Proposed Educational Institution (Academic Facilities and its Associated Ancillary Facilities) with Permitted Flat Use (Staff Quarters) in “Residential (Group B)” Zone at Inland Lot No. 7704 RP (Part), Pokfield Road, Hong Kong

Subject : **Sewerage Impact Assessment**
Submission Date : **07 July 2025**
Document No. : **WH67022-REPORT-SW-0003**

Sewerage Impact Assessment

Issue/revision (Remarks) Date	Issue 1 02/11/2020	Issue 1a 02/12/2020 (Response to EPD's Comment)	Issue 2 29/01/2021 (Response to EPD's and DSD's Comment)	Issue 3 07/07/2025 (Section 16 Application for R(B) Zone)		
Prepared by Signature	Andrew Ngai	Andrew Ngai	Andrew Ngai	Ho-Ching Cheung		
Checked by Signature	Jacky Lam	Jacky Lam	Jacky Lam	Ricky Wong		
Authorized by Signature	Tracy Choi	Tracy Choi	Ben Wong	Ricky Wong		
Job number File reference	WH67022	WH67022	WH67022	WH67022

Indicative Floor Plan (LG1)

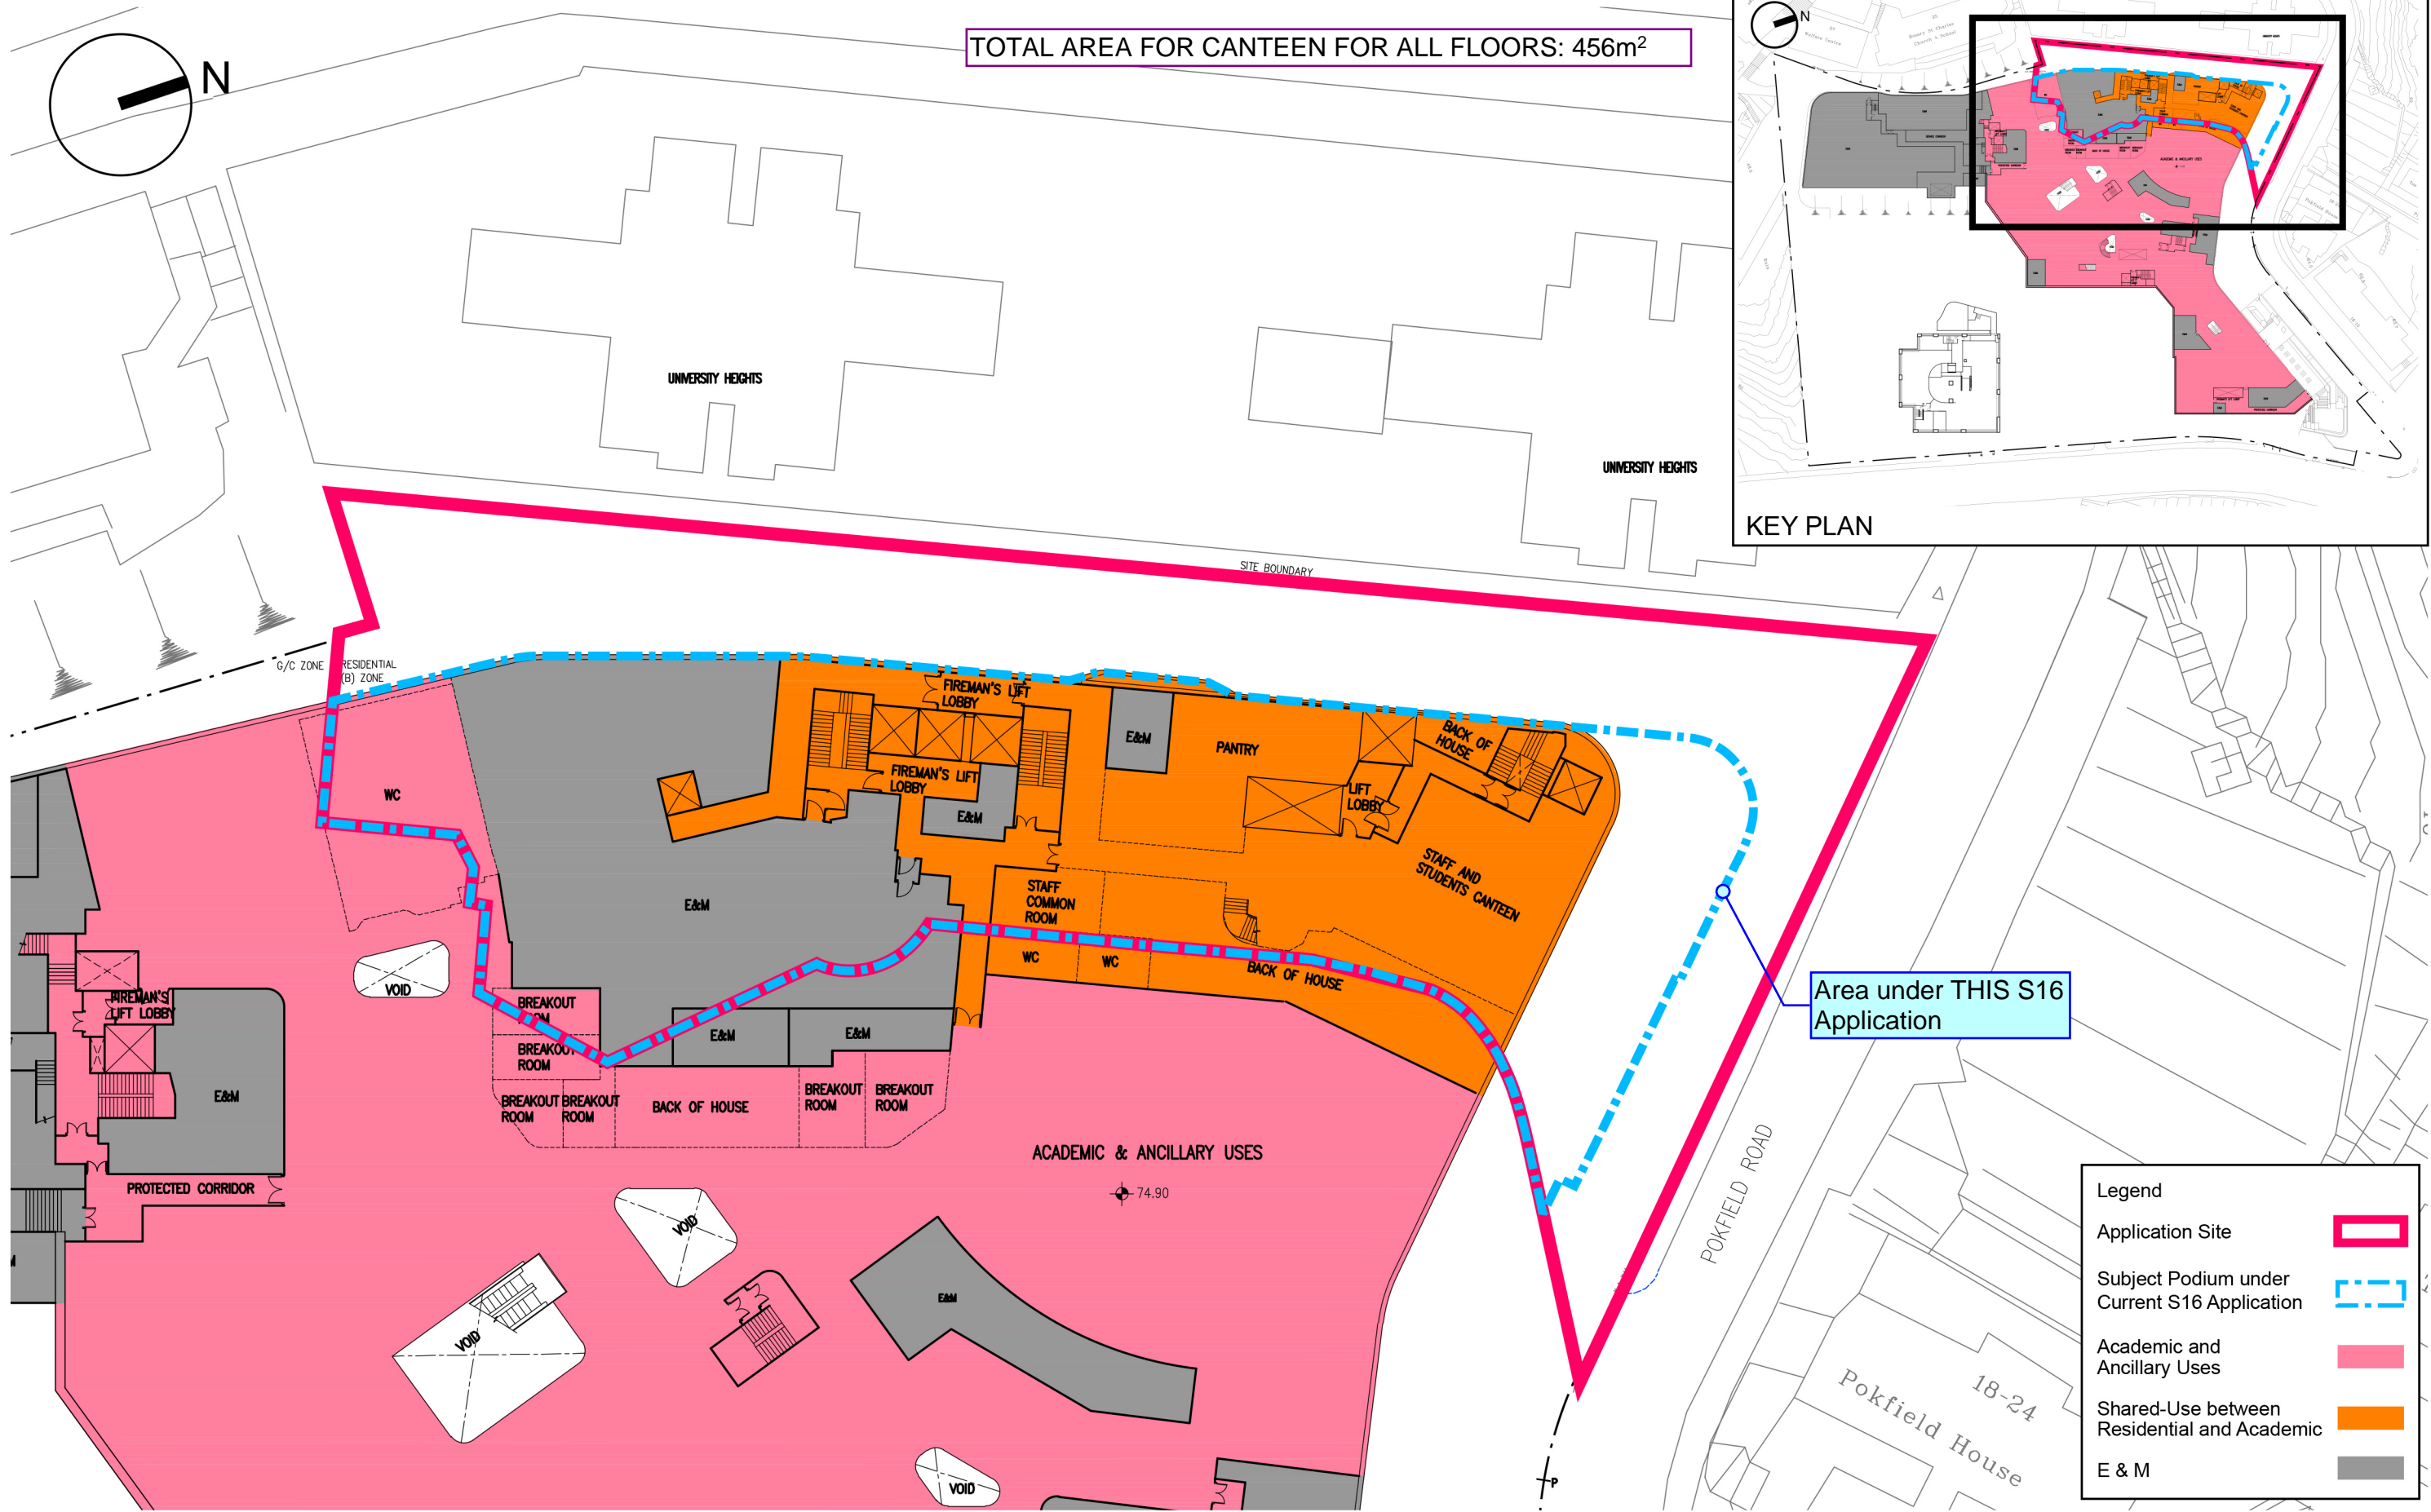
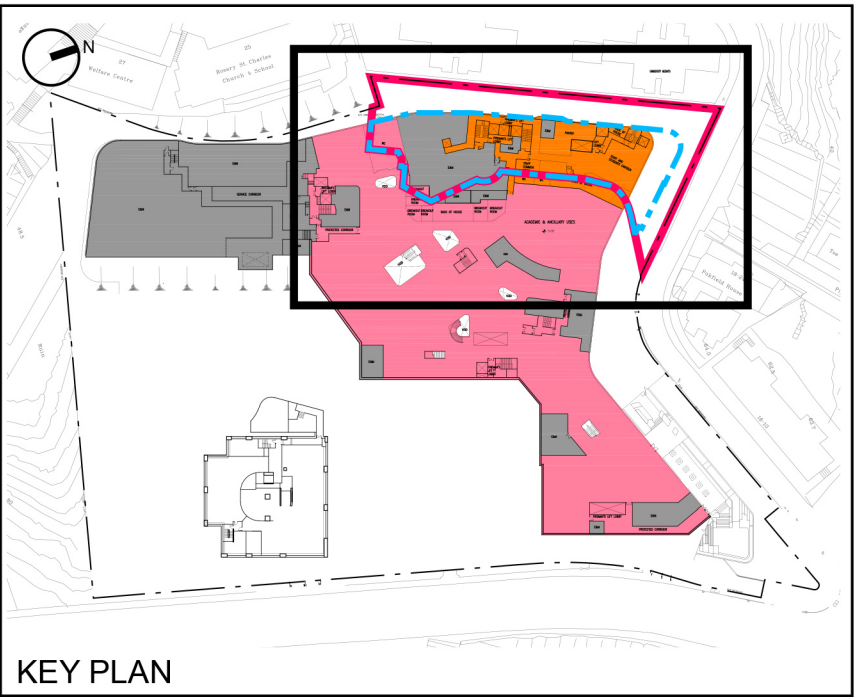
In this application, SIG noticed that canteen area has been incorporated in the architectural layout plans and requested an updated Sewerage Impact Assessment (SIA) to cover these proposed layouts.

Area considered for
restaurants and
canteen: 457m²

TOTAL AREA FOR CANTEEN FOR ALL FLOORS: 456m²

Upon review of the latest approved SIA dated 29th Jan. 2021 (Refer to EPD’s reply dated 1 June 2021 enclosed in Appendix A1), and the total canteen area proposed in this recent Section 16 application, it is deduced that the latest and previously EPD approved SIA is similar to the total canteen areas of this Section 16 application. Refer to Appendix A1. Therefore, the estimated sewerage flow from the area covered by this application shall be like that assessed and covered in the latest and previously EPD approved SIA submission.

Drawing No.	Drawing Title
HKU-SIA-LP-001	Existing Sewerage Sub-Catchments Layout Plan
HKU-SIA-LP-002	Proposed Sewerage Sub-Catchments Layout Plan

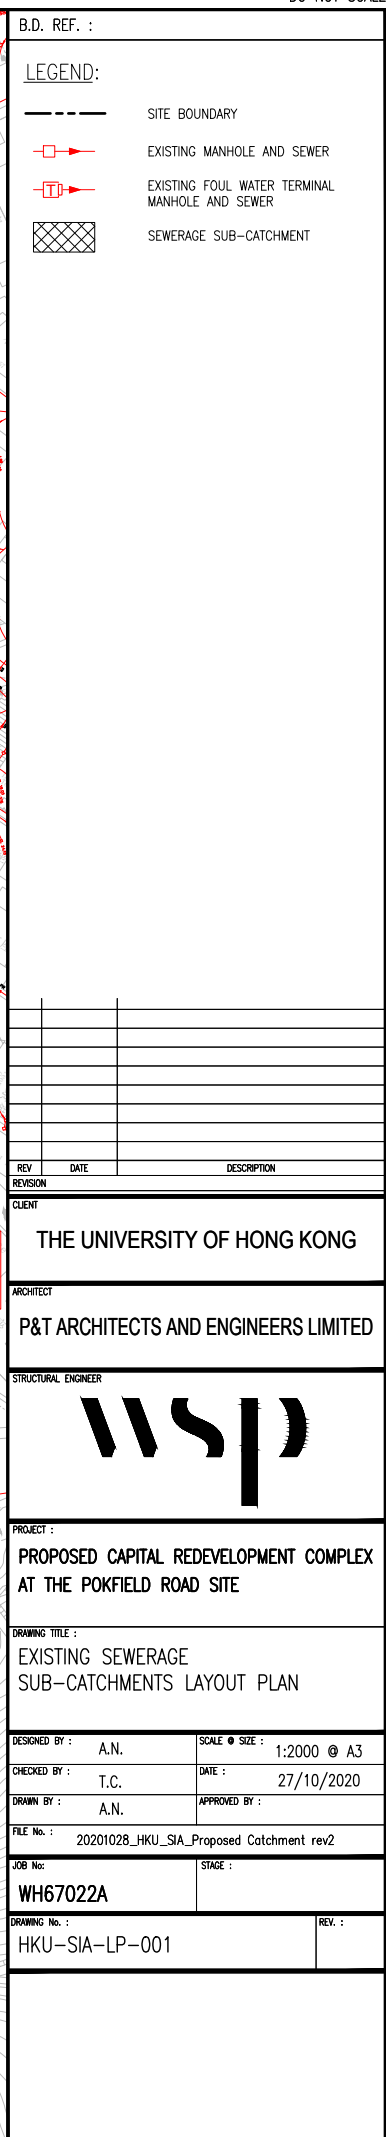
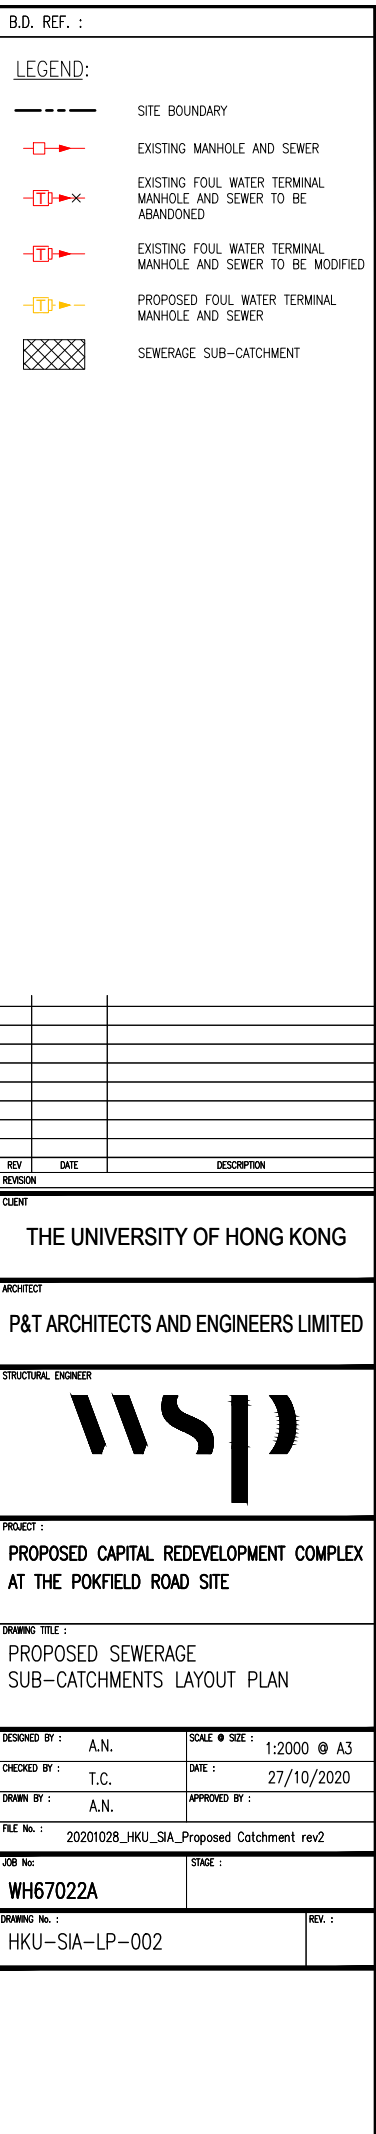
3. Table 4.1 Sub-catchment C: Please double check if the discharge point of University Heights is FMH7005407 or FMH7005374 and revise the sub-catchment layout accordingly.

4. Appendix A: The average domestic household size as 3.0 is considered underestimated. The appropriate average domestic household size should be adopted according to their corresponding Tertiary Planning Unit under 2016 Population By-Census.

5. Appendix A: Please clarify whether there will be any swimming pool in the redevelopment.
6. Appendix B: Sub-catchment C: Typo "Private R1" shall read as R4 as UFF of 0.37 is applied.
